Addendum 47 – UN Regulation No. 48

Revision 12 - Amendment 10

07 series of amendments – Date of entry into force: 25 September 2020

Uniform provisions concerning the approval of vehicles with regard to the installation of lighting and light-signalling devices

"Arrangements of approval marks

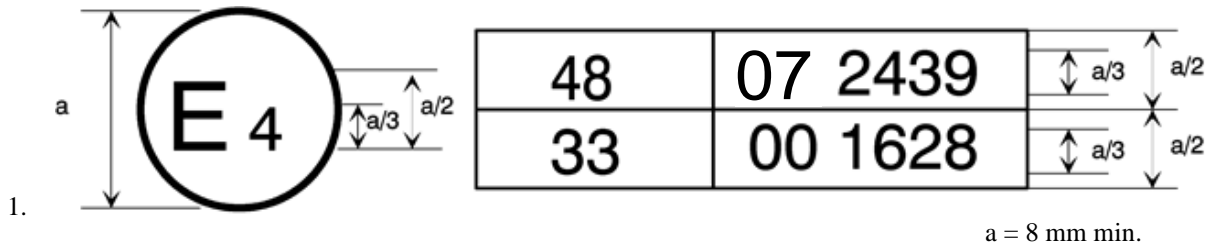
Annex 2, amend to read:

Model A
(See paragraph 4.4. of this Regulation)

a = 8 mm min.

The above approval mark affixed to a vehicle shows that the vehicle type concerned has, with regard to the installation of lighting and light-signalling devices, been approved in the Netherlands (E 4) pursuant to UN Regulation No. 48 as amended by the 07 series of amendments. The approval number indicates that the approval was granted in accordance with the requirements of UN Regulation No. 48 as amended by the 07 series of amendments.

Model B
(See paragraph 4.5. of this Regulation)

The above approval mark affixed to a vehicle shows that the vehicle type concerned has been approved in the Netherlands (E 4) pursuant to UN Regulation No. 48 as amended by the 07 series of amendments and UN Regulation No. 33.⁵ The approval number indicates that, at the dates when the respective approvals were given, UN Regulation No. 48 was amended by the 07 series of amendments and UN Regulation No. 33 was still in its original form.
